Sumter City-County Board of Zoning Appeals

BOA-26-29, 7056 Camden Hwy. (County)

The Board of Zoning Appeals will consider a request from Harmoni Gateway Towers, LLC to establish a 279 ft. tall telecommunications tower on the property. The Zoning Administrator has referred this request to the Board of Zoning Appeals consistent with *Article 5.b.4: Communication Towers and Antenne of the Sumter County Zoning & Development Standards Ordinance*. The property is located at 7056 Camden Hwy., is zoned Agricultural Conservation (AC), and is identified as TMS# 088-00-03-028.

Appeals - Variance - Special Exception

Figure 2 – Proposed site development plan

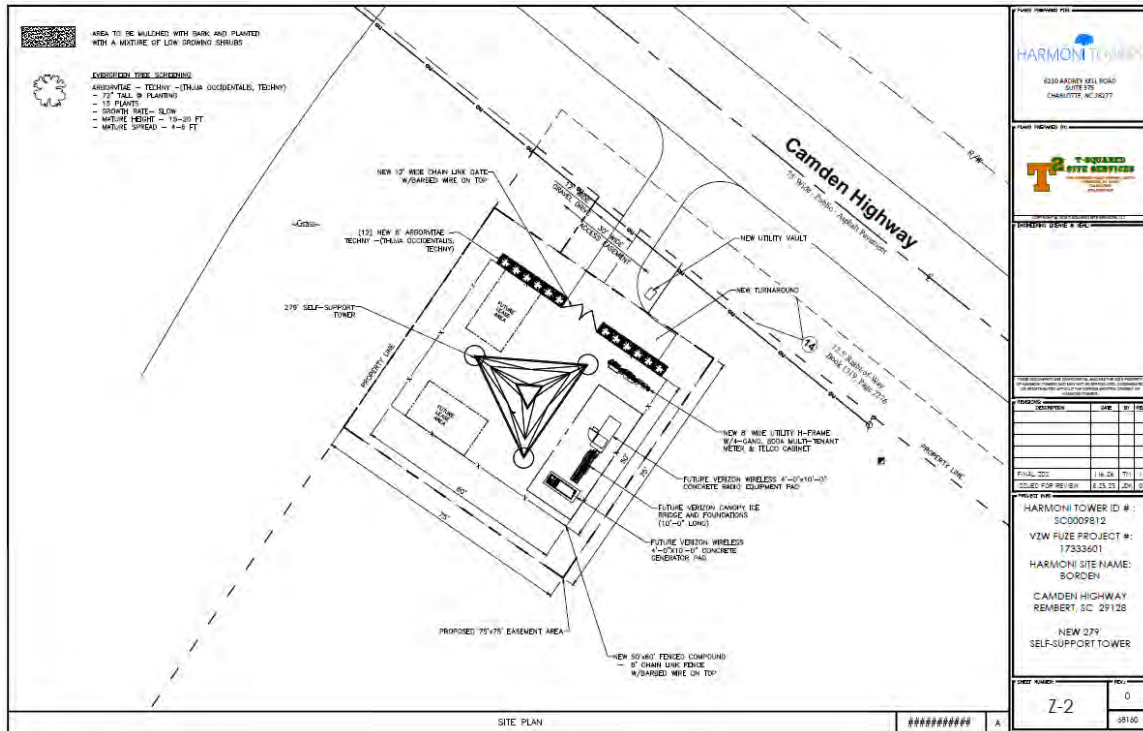
While engineers can design telecommunications towers to buckle or fold over on themselves, the proposed fall zone represents only 13.4% of the tower's total height. Expecting a freestanding structure of this size to collapse so perfectly that no part of it lands beyond that distance is highly unrealistic and outside standard engineering safety margins. Where manufacturers provide certified "fall zone letters" utilizing advanced hinge-point calculations, the legal and physical minimum limit typically stops at 33% to 50% of the total height.

Figure 3 – Proposed tower elevation drawing with Antenna Locations Identified

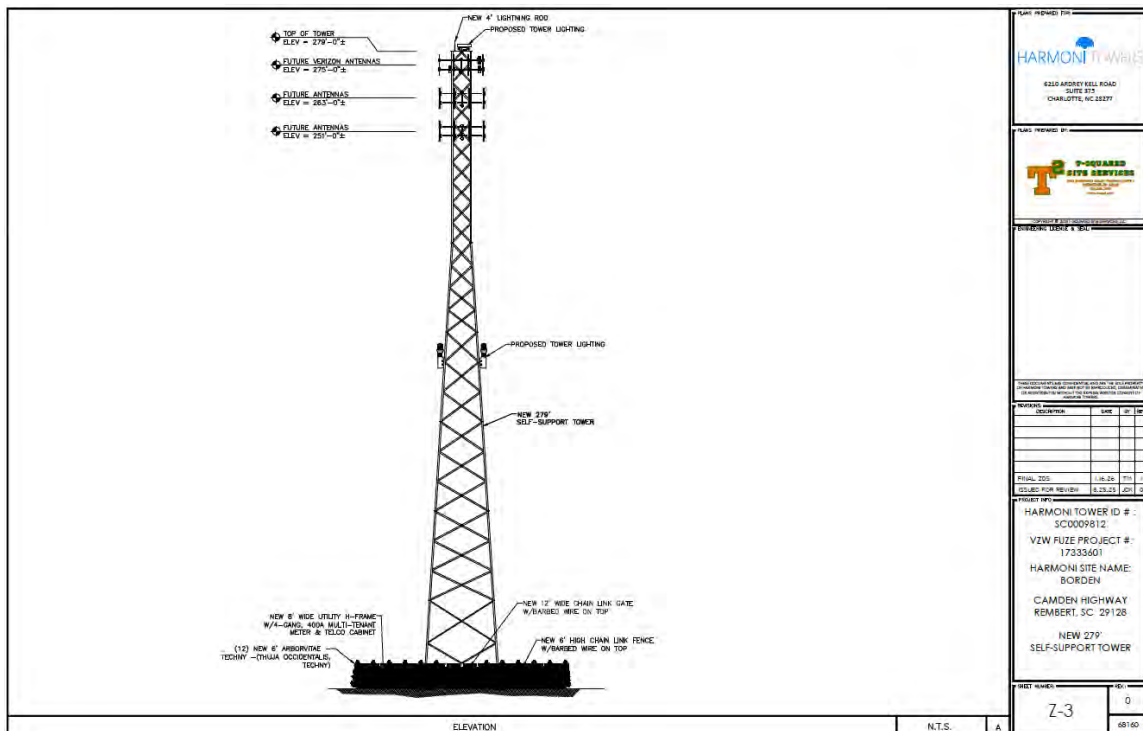
- The applicant's design plans indicate three separate antenna arrays. The top array is identified for future Verizon antennas, and the two additional arrays are unspecified as to future users.
